REMARKS

This paper responds to the Office Action mailed on November 1, 2005.

TITLE: MICROSTRIP LINE DIELECTRIC OVERLAY
INVENTORS NAME: Roy Greeff
DOCKET NO.: 303.881US1

Fig. 6

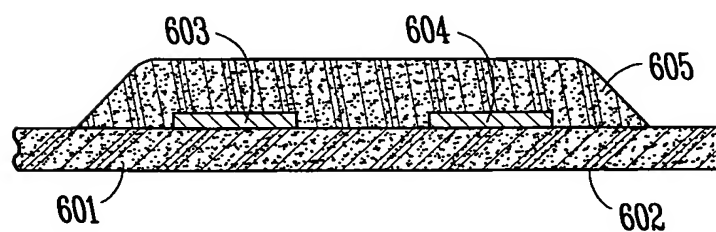
In contrast, the pending independent claims 1, 7, 13, 18, 23, and 30 (as amended to reflect the limitations of cancelled claims 5, 10, 16, 19, 29, and 33) recite a dielectric coating applied over at least one microstrip line in a thickness greater than an average thickness of the conformal coating material across the printed circuit board or substrate. Figure 6 also shows selective placement of a dielectric material 605 on a substrate 601, such that the dielectric coating 605's thickness over microstrip lines 603 and 604 is greater than the average dielectric coating thickness across the area of substrate 601.
